STATE OF NORTH CAROLINA
DEPARTMENT OF TRANSPORTATION

Subject: **Request for Revision to Section 404 Nationwide Permit, Section 401 Water Quality Certification** for the Proposed Replacement of Bridge No. 8 on NC 194 over the North Fork New River in Ashe County; TIP BR-0002, Division 11, Debit \$240 from WBS Element 67002.1.1

Reference: Section 404 Permit, (Action ID SAW-2019-02373), issued February 11, 2020
Section 401 Water Quality Certification (NCDWR Project No. 20191658), issued December 19, 2019

PERMIT DRAWING
SHEET 2 OF 7

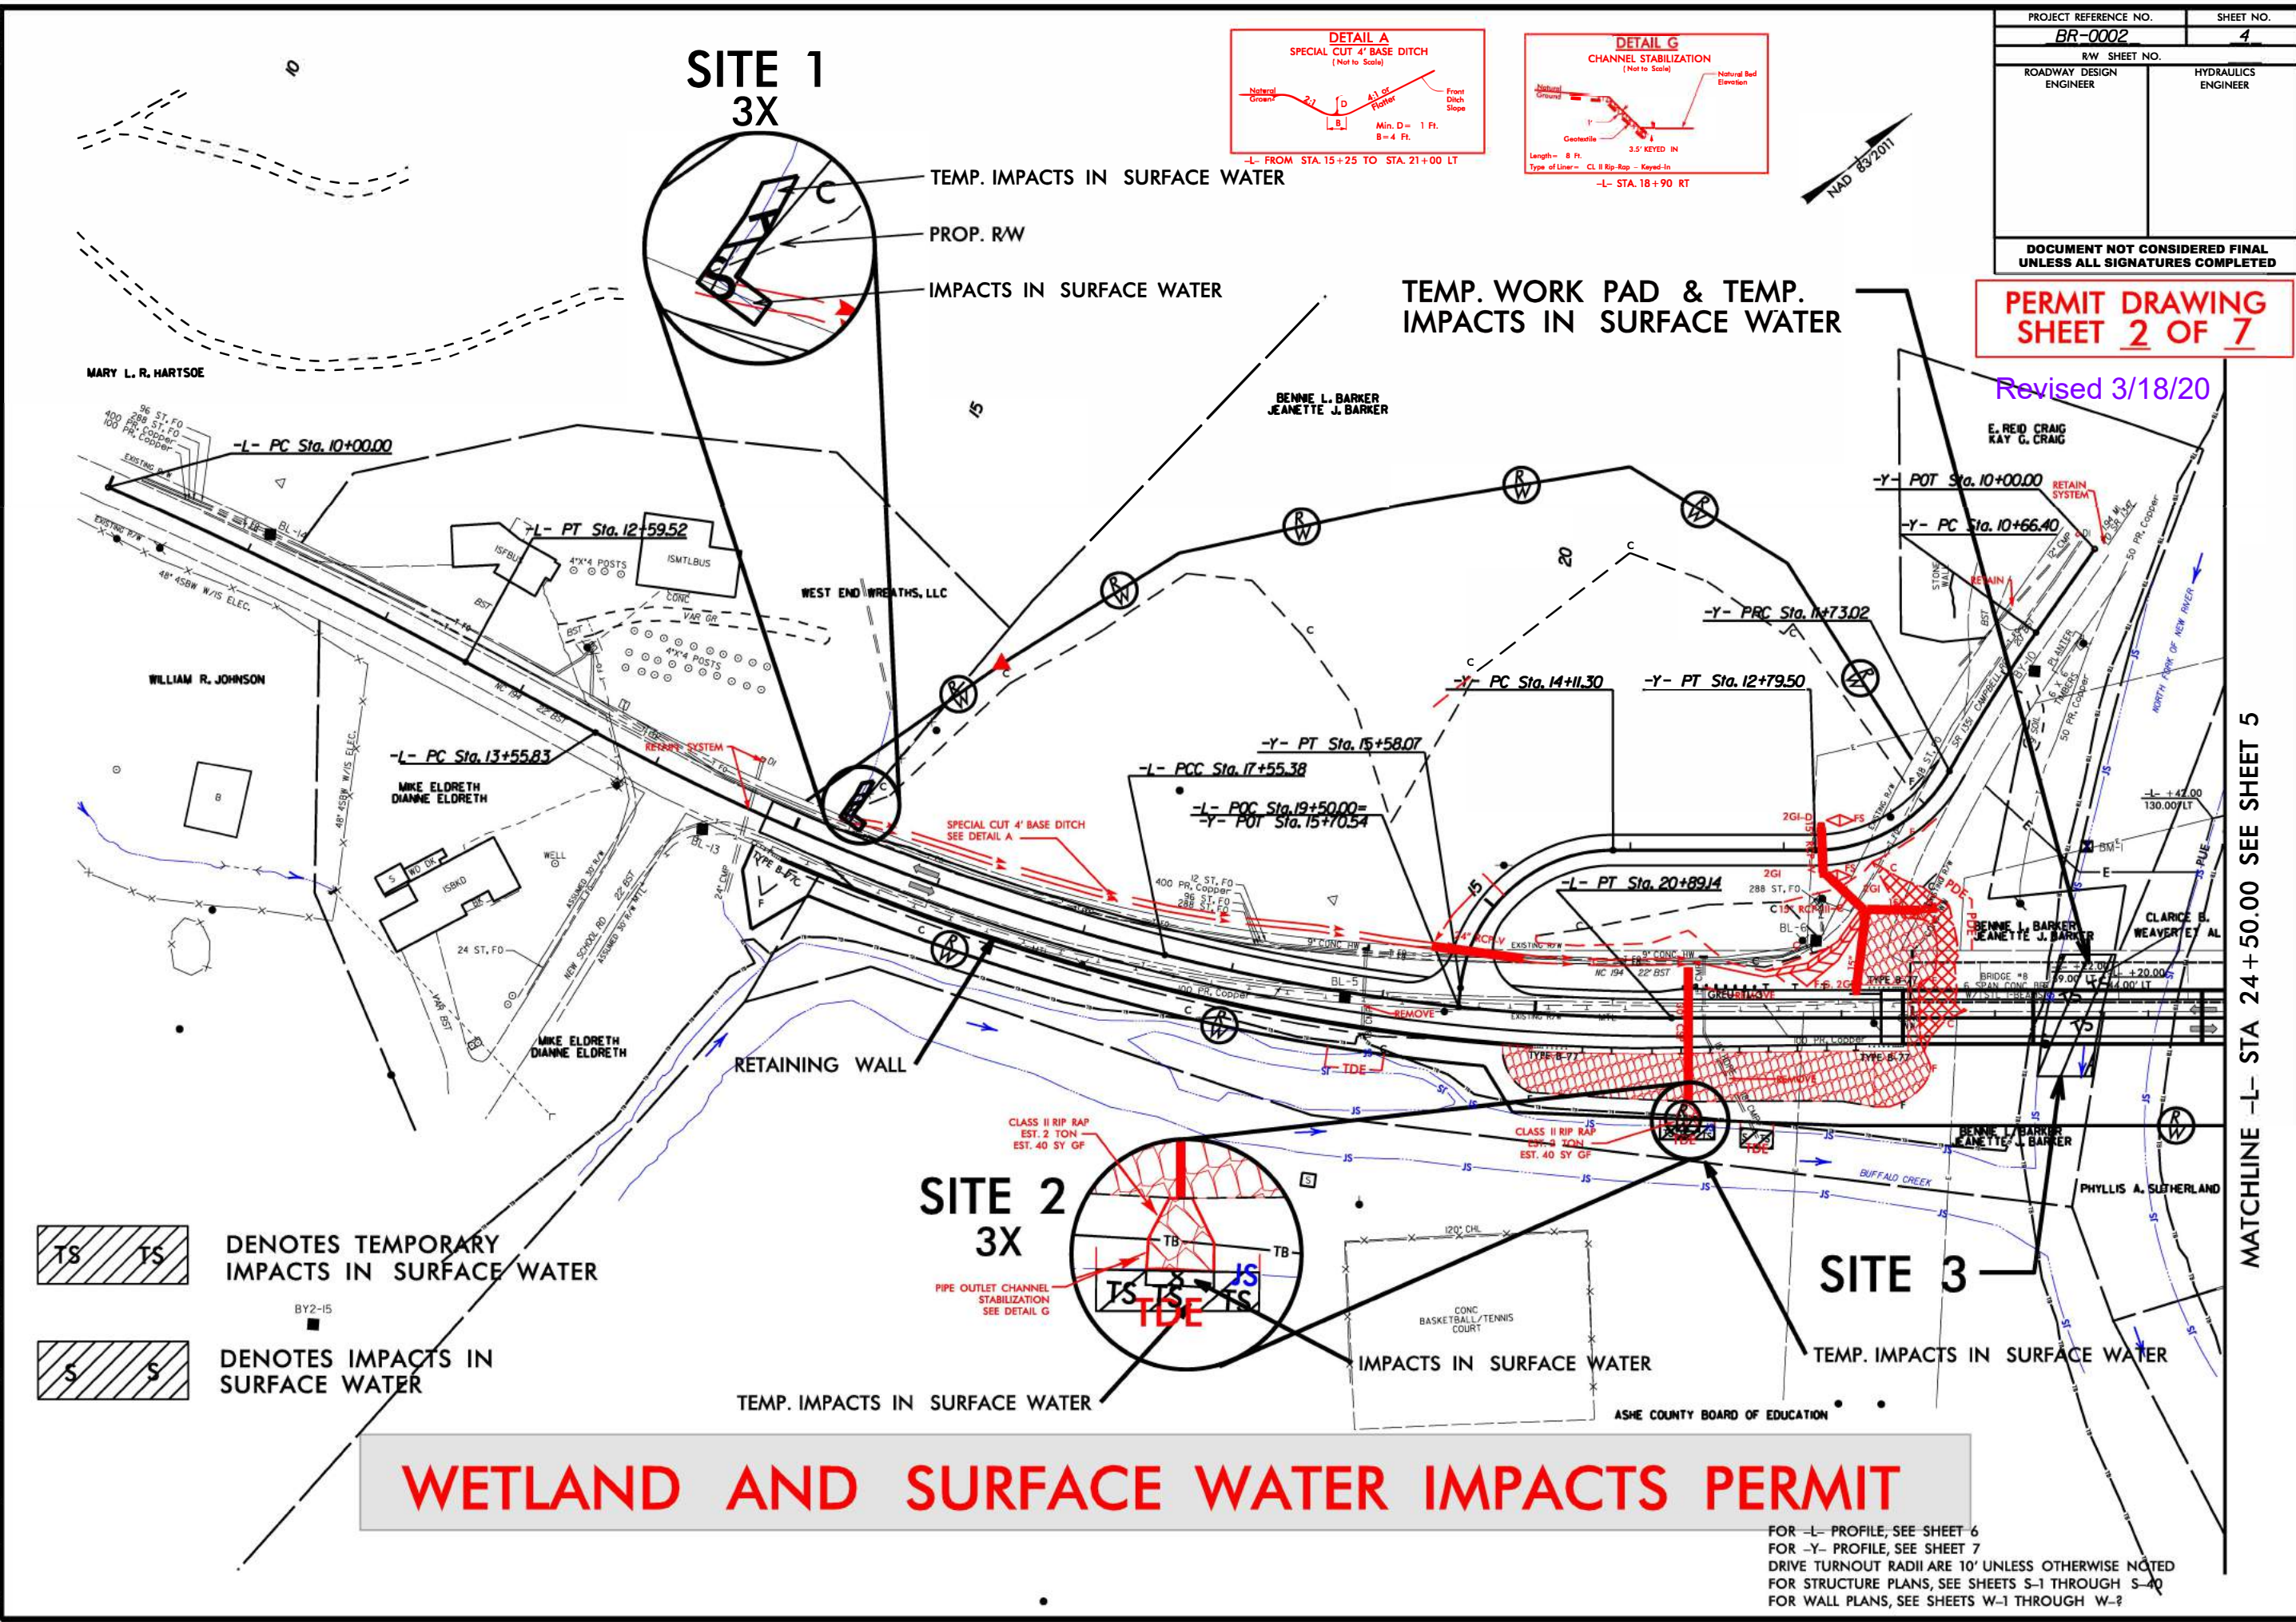
The retaining wall, established to avoid impacts to Buffalo Creek, will shift five additional feet away from the stream.

A new corrugated steel pipe (CSP) that was previously proposed to exit through the wall and discharge into Buffalo Creek, will now be shifted eastward, outside of the wall area. This will allow the pipe to outlet approximately 9 feet further away from Buffalo Creek than the original design.

Permanent impacts to Buffalo Creek reduced by 3 lf (from 18 lf to 15 lf) required for the keyed-in bank stabilization in Buffalo Creek.

Temporary impacts have increased 31 lf (from 11 lf to 42 lf). This is the result of the need to remove the 18" CMP that was going to be replaced and discharged through the wall.
